# Access Compliance Report

## Public Rights-of-Way

### (Curb Ramps)

Intersection ID: 11369	Main Street: CATAWBA_AV	Cross Street: LOLA_AV	Location: SE
ADA ID: B652D716D0F5	Ramp Type: BlendTrans2	Initial Pass/Fail: Fail	Overall Compliance: No
		Severity Score: 8.75

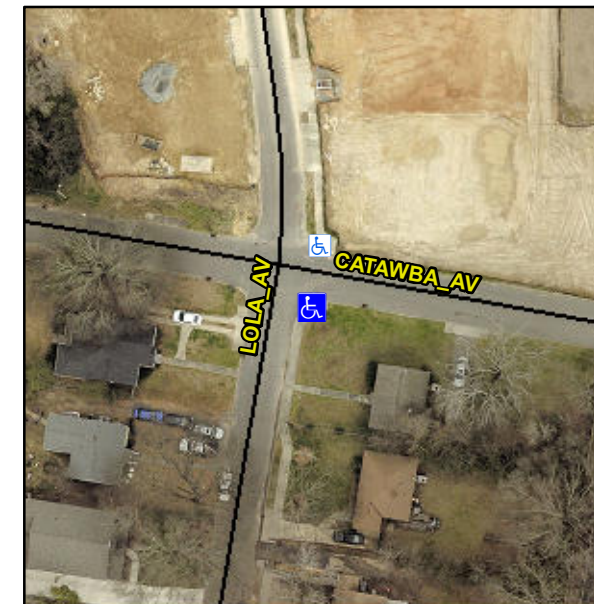
**NO LT SW**

**Not Found, R304.5.1**

**Remove & Replace Curb Ramp With Two New Directional Ramps or Equivalent.**
